RANGELINE BUSINESS PARK SUBDIVISION, UNIT TWO, RESUBDIVISION OF LOTS 10 & 11

APPLICATION NUMBER 5 DATE March 17, 2022
APPLICANT Rangeline Business Park Subdivision, Unit Two, Resubdivision of Lots 10 & 11
REQUEST Subdivision

DETAIL SITE PLAN

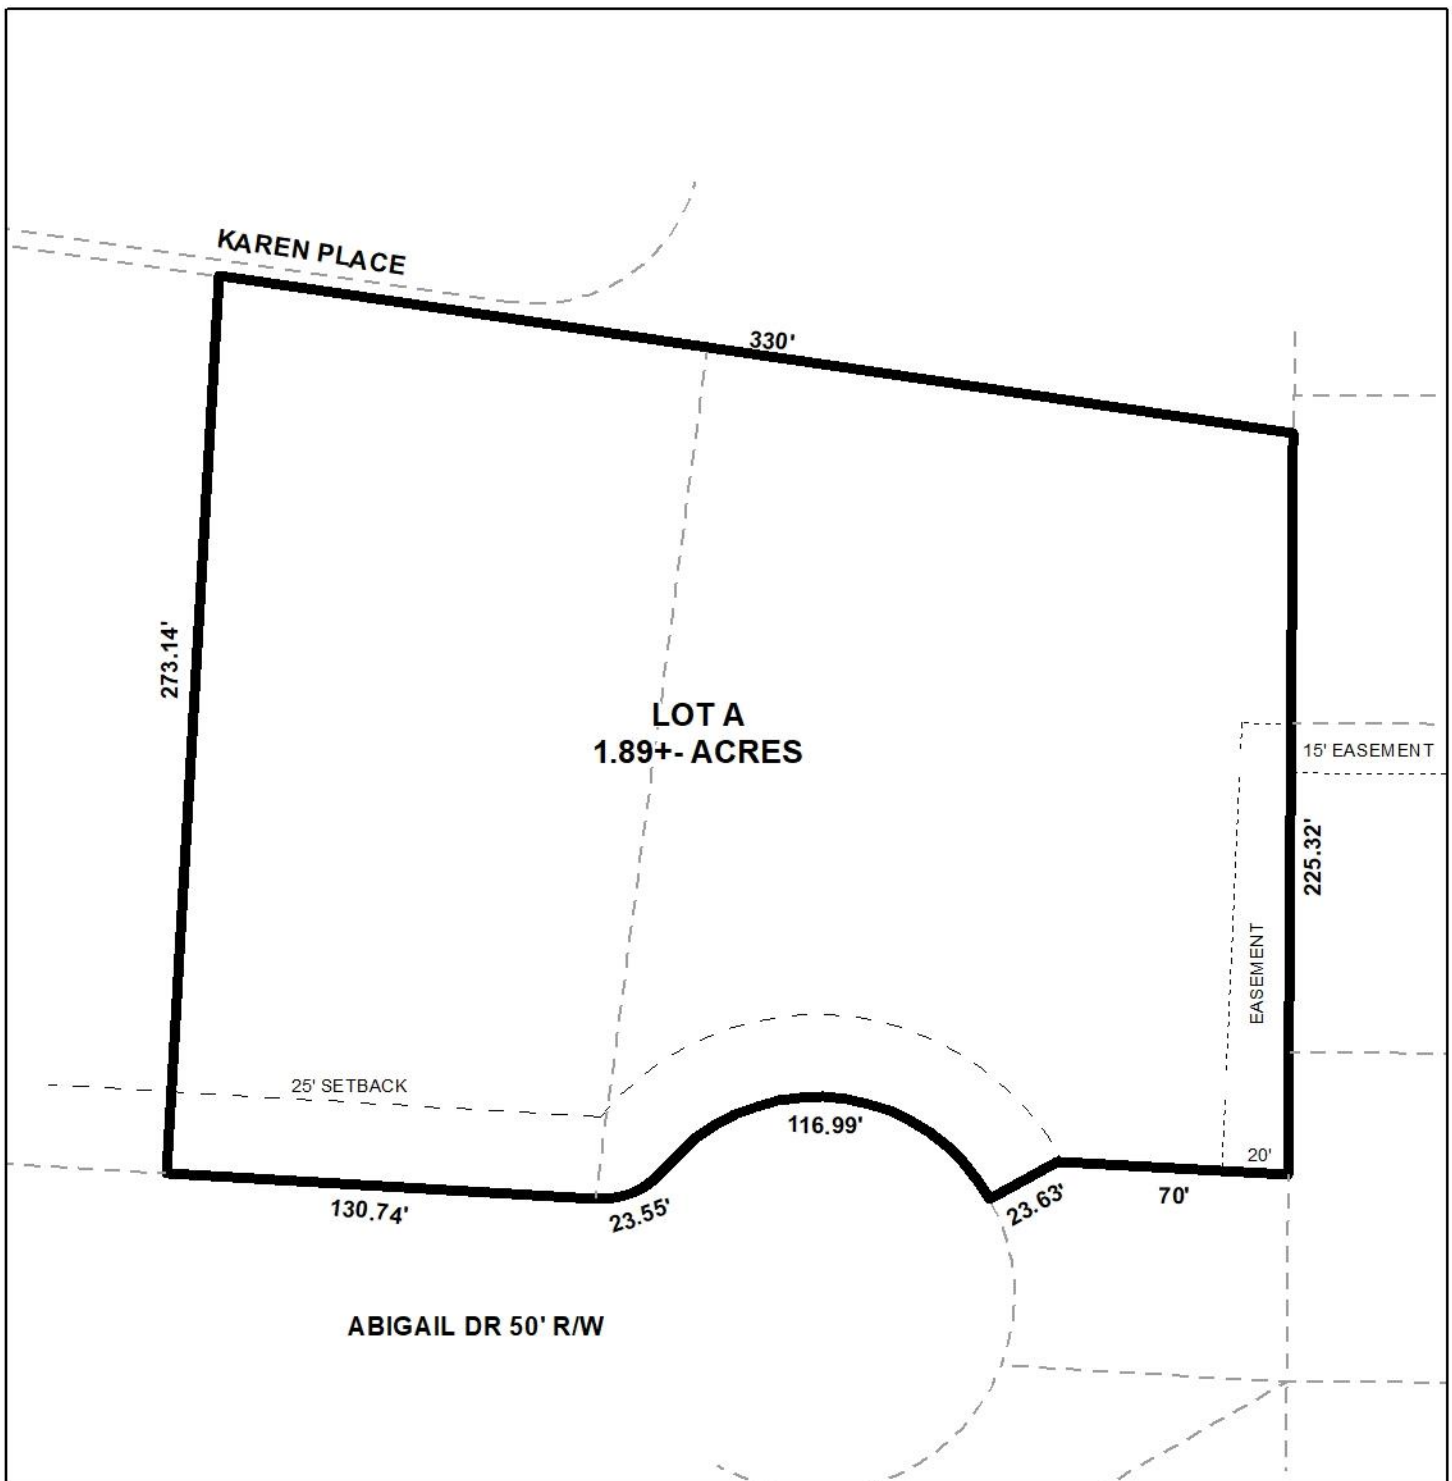
- B. Provide and label the monument set or found at each subdivision corner.
- C. Add a graphic scale.
- D. The vicinity map is not legible except for the street names.

- E. Show and label all flood zones. New maps went into effect on June 5, 2020.
- F. Provide NOTE 1 that is referenced in the Common Area. The existing DRAINAGE EASEMENT also referenced a NOTE 1 on the original Plat.

- I. The Drainage Easement along the SE side of LOT A shall be marked as "PRIVATE DRAINAGE EASEMENT".
- J. Add a note to the SUBDIVISION PLAT stating that as shown on the 1984 aerial photos LOT A will receive historical credit of existing (1984) impervious area towards stormwater detention requirement per Mobile City Code, Chapter 17, Storm Water Management and Flood Control) as follows: LOT A – NONE.

The proposed lot has frontage along Abigail Drive, a minor street with curbing and gutter illustrating a compliant 50-foot right-of-way. On the North side of the subject site the proposed lot has approximately 100' of frontage along Riverwood Cove, a minor street without curb and gutter located outside of the Mobile City Planning Jurisdiction. It should be noted that the preliminary plat incorrectly illustrates Riverwood Cove as Karen Place and should be revised on the Final Plat.

The 25-foot minimum building setback line is illustrated along Abigail Drive, per Section V.D.9. of the Subdivision Regulations, and should be retained on the Final Plat, if approved. The 25-foot minimum building setback line is not illustrated along Riverwood Cove. As such, if approved, the Final Plat should be revised to illustrate a compliant setback line along Riverwood.

The preliminary plat indicates an existing drainage easement along the Eastern lot line of the subject site. Therefore, a note should be required on the Final Plat stating that no structure may be constructed or placed within any easement without the permission of the easement holder.

- 1) Revision of the Final Plat to change the label for “Karen Place” to “Riverwood Cove”;
- 2) Retention of the lot’s size in acres and square feet on the Final Plat, or provision of a table on the Final Plat providing the same information;

- 3) Retention of the 25-foot minimum building setback line along Abigail Drive, in compliance with Section V.D.9. of the Subdivision Regulations;
- 4) Depiction of a 25-foot minimum building setback line where the subject site fronts Riverwood Cove;

- 5) Inclusion of a note on the Final Plat stating that no structure may be constructed or placed within any easement without the permission of the easement holder;
